**DEVELOPED DRAINAGE CONDITIONS
(KETTLE CREEK BASIN)**

RETAIL RANCH
PRELIMINARY/FINAL DRAINAGE REPORT
DEVELOPED DRAINAGE MAP

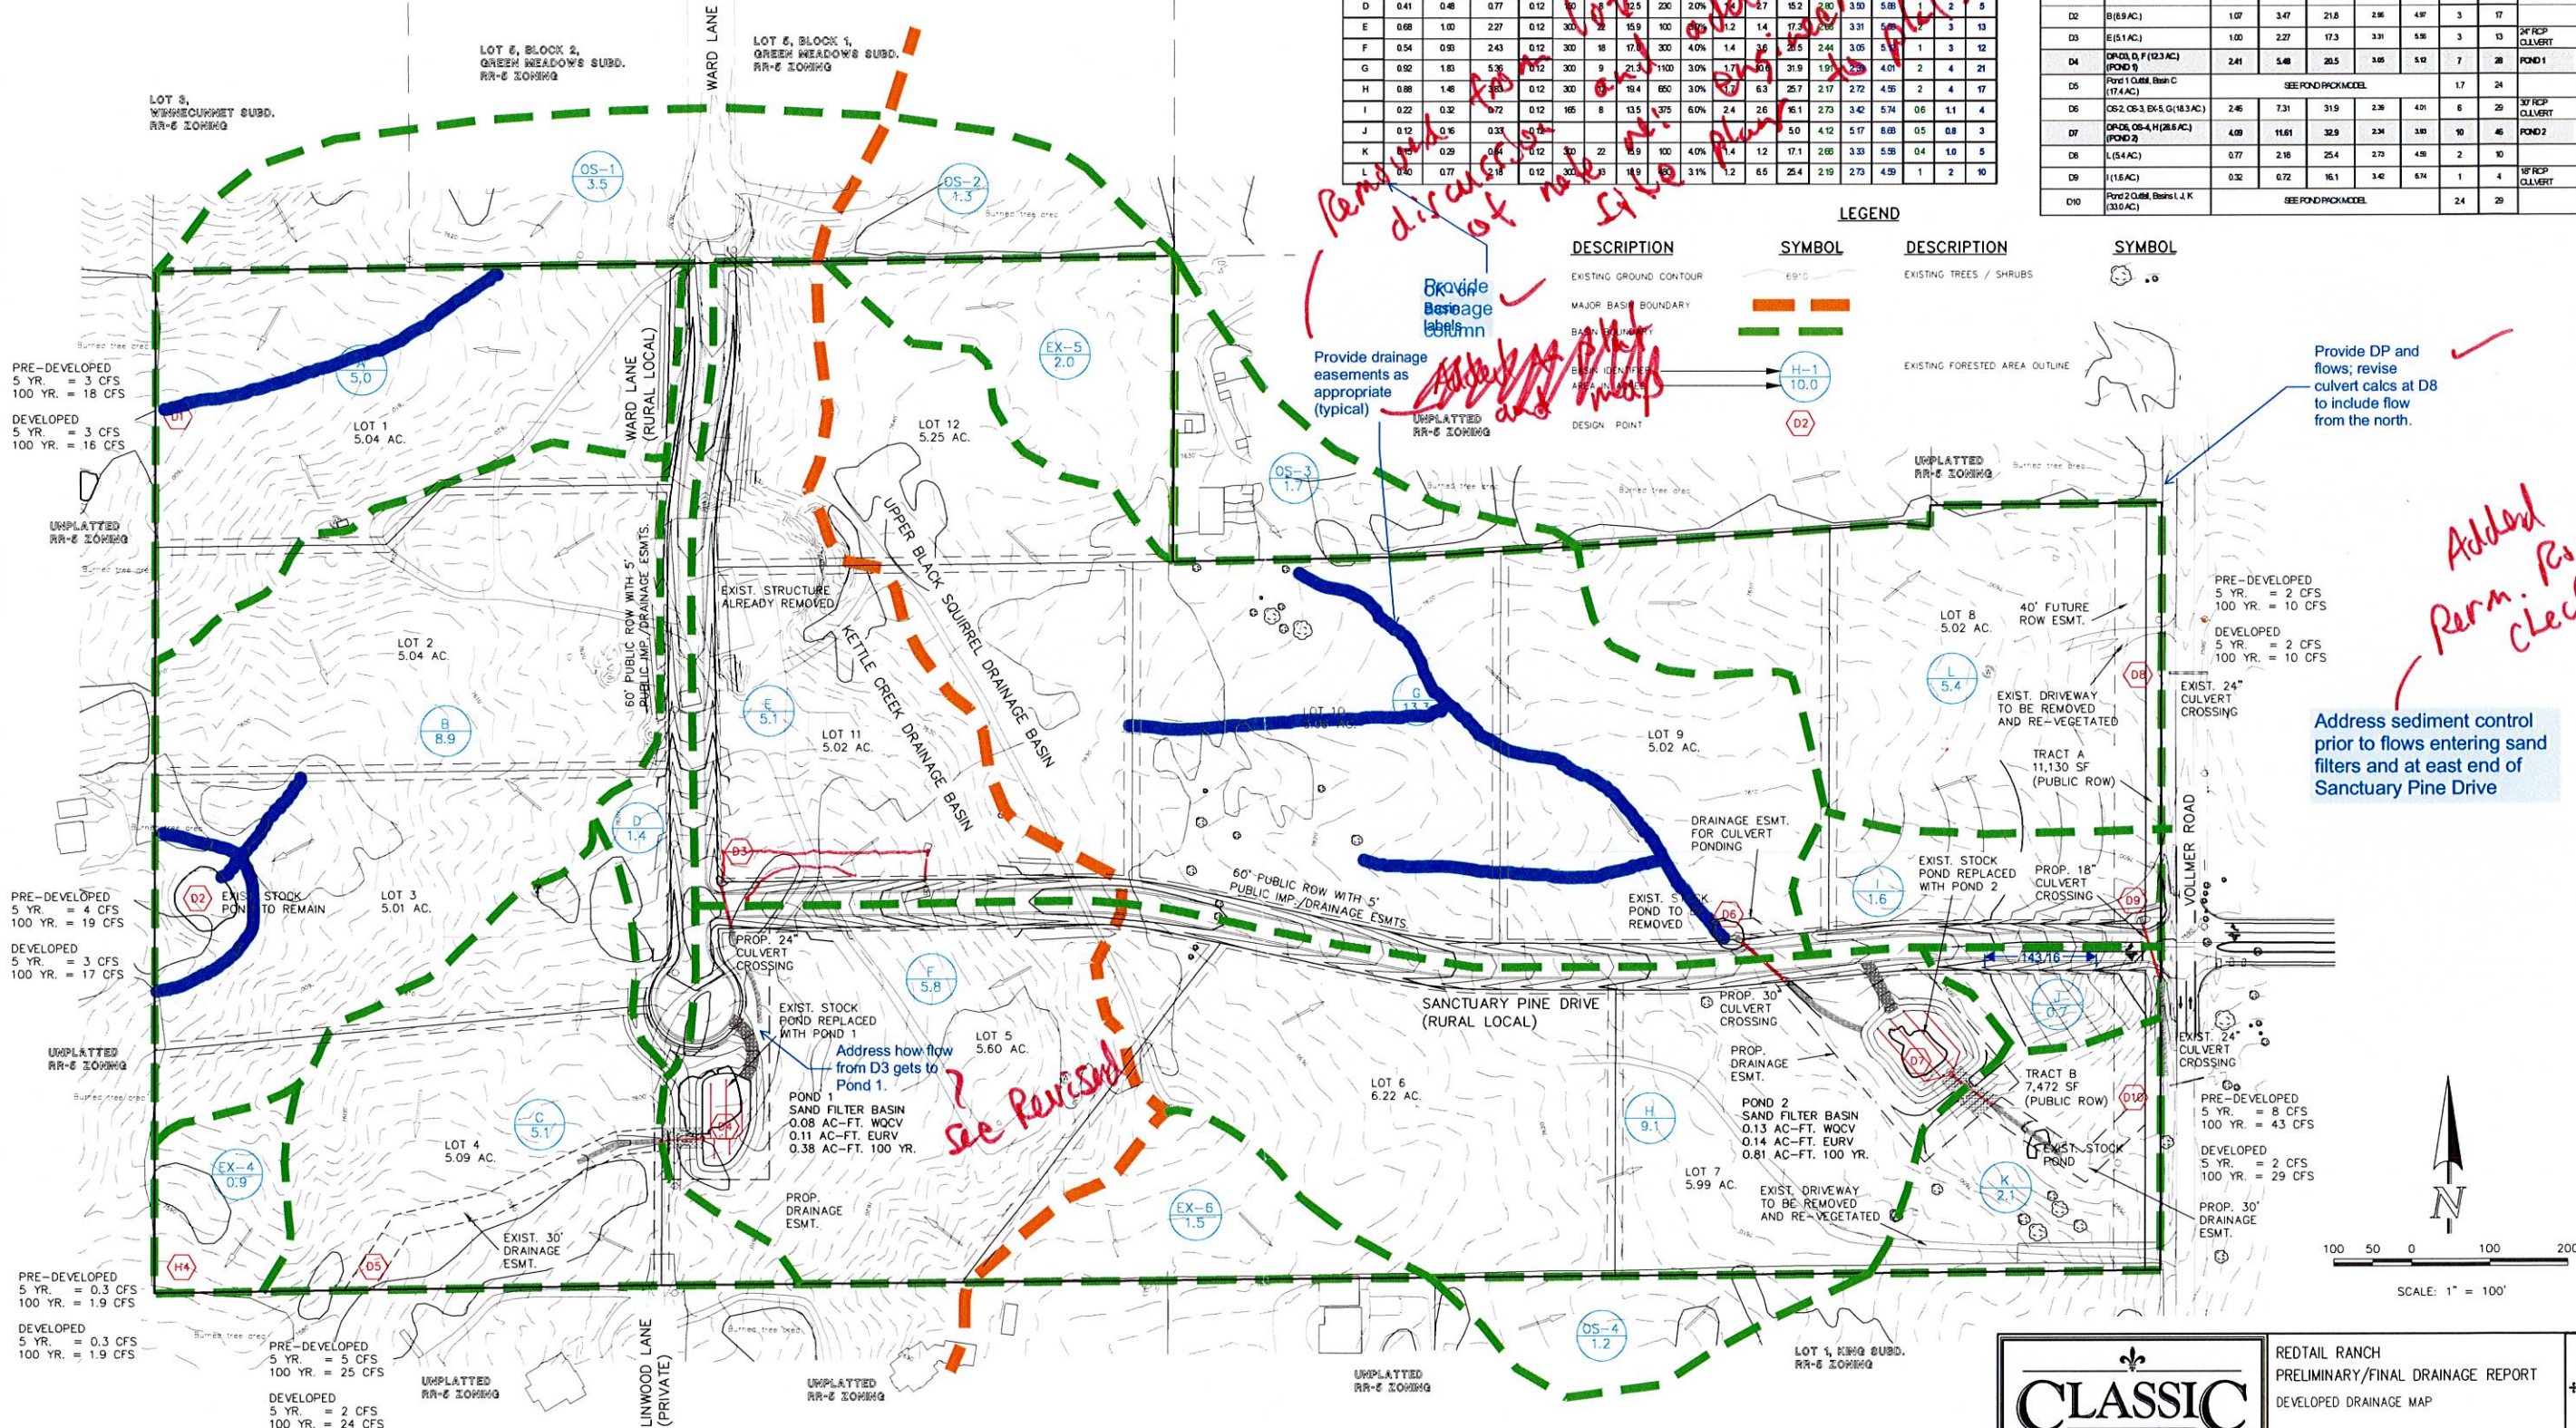
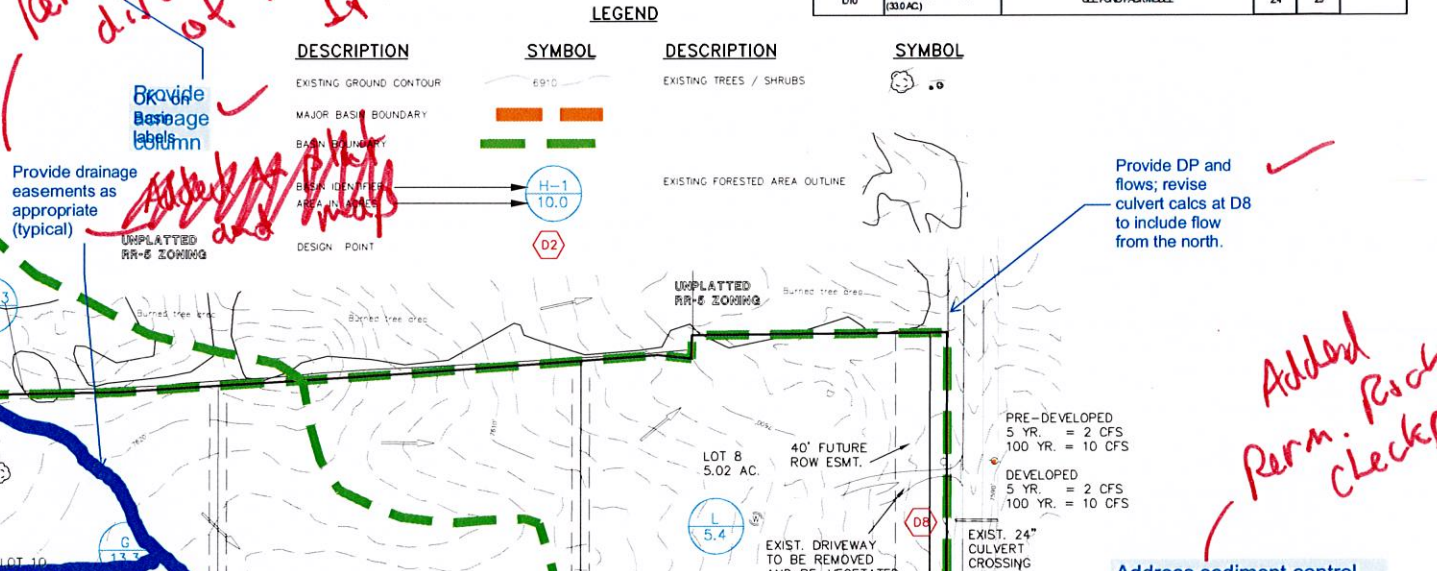
The previous comment was made "Address sediment control" Please provide information in the report that calls out where velocities exceed criteria (5fps) in roadside ditches and call out where permanent rip rap checks will be installed in these high velocity areas

see revised text and plans
